<b>AMENDMENT OF SOLICITATION/MODIFICATION OF CONTRACT</b>				1. CONTRACT ID CODE <b>J</b>	PAGE OF PAGES <b>1   2</b>
2. AMENDMENT/MODIFICATION NO. <b>0003</b>		3. EFFECTIVE DATE <b>01-Jul-2004</b>	4. REQUISITION/PURCHASE REQ. NO. <b>W13G86-4113-6534</b>		5. PROJECT NO.(if applicable)

14. DESCRIPTION OF AMENDMENT/MODIFICATION (Organized by UCF section headings, including solicitation/contract subject matter where feasible.) Amendment is necessary to delete and revise Drawing Sheets 12 and 13. There is no change to the bid opening date or time as a result of this amendment.					
Except as provided herein, all terms and conditions of the document referenced in Item 9A or 10A, as heretofore changed, remains unchanged and in full force and effect.					
15A. NAME AND TITLE OF SIGNER (Type or print)			16A. NAME AND TITLE OF CONTRACTING OFFICER (Type or print)		
			TEL:	EMAIL:	
15B. CONTRACTOR/OFFEROR		15C. DATE SIGNED	16B. UNITED STATES OF AMERICA		16C. DATE SIGNED
_____ (Signature of person authorized to sign)			BY _____ (Signature of Contracting Officer)		<b>01-Jul-2004</b>

U.S. ARMY SOLDER SYSTEMS CENTER  
NATICK MASSACHUSETTS  
BUILDING 45 OFFICE RENOVATION

Reference number:  
**M-2**  
Sheet 12 of 21

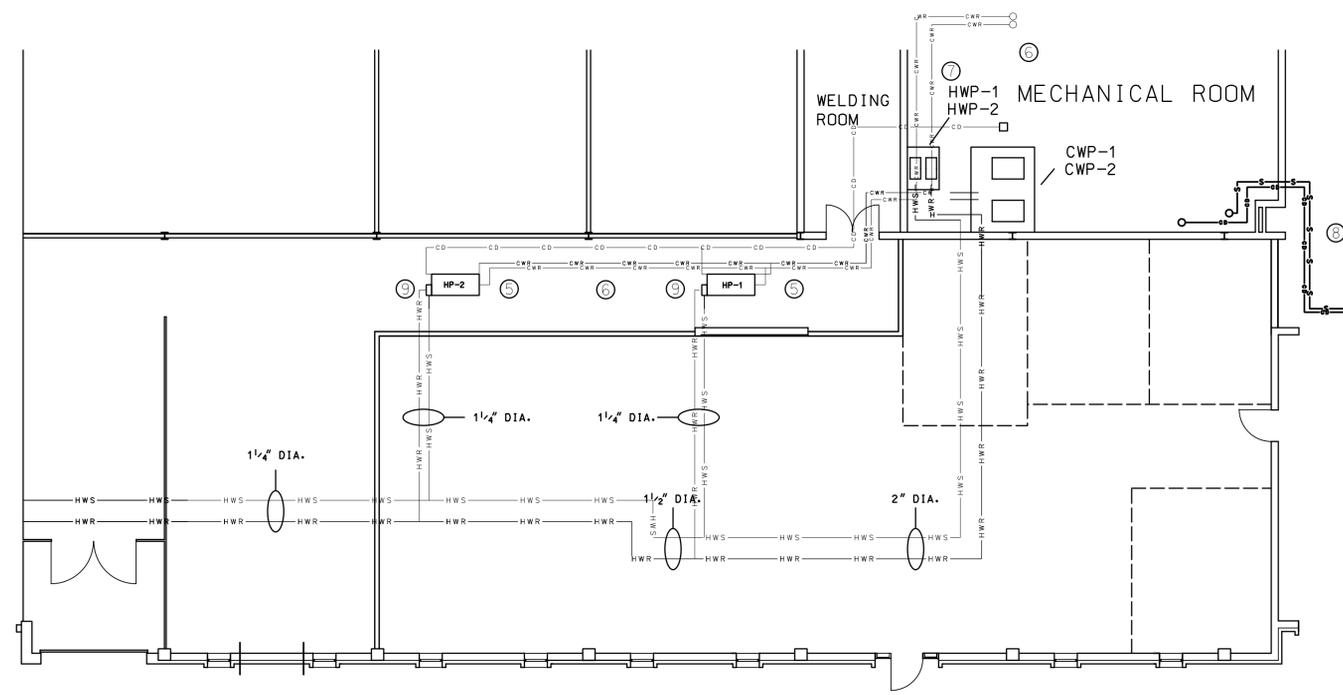
Sheet 12, Reference Number M-2, NEW MECHANICAL EQUIPMENT PLAN  
(Notes revised, zone numbers added)

Rev.	Date	Description
1	17/1/04	NOTES REVISED - ZONE NUMBERS ADDED

**MECHANICAL EQUIPMENT SCHEDULES**

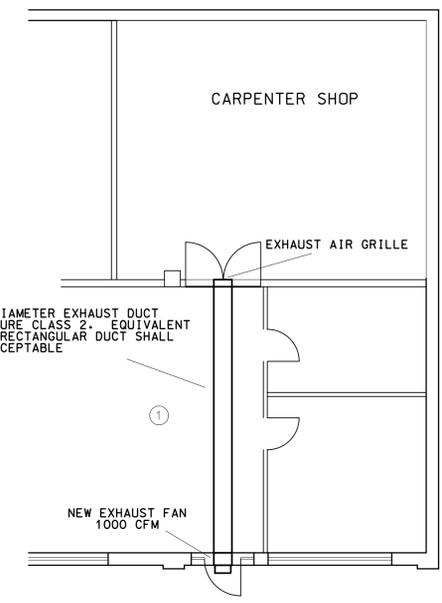
Sheet 13, Reference Number M-3, MECHANICAL EQUIPMENT SCHEDULES  
(Hot Water Pump revised, Hot water coils revised, ZD-1 revised, bypass dampers added)

Rev.	Date	Description
1	7/1/04	HOT WATER PUMPS REVISED, HOT WATER COILS REVISED, ZD-1 REVISED, BYPASS DAMPERS ADDED
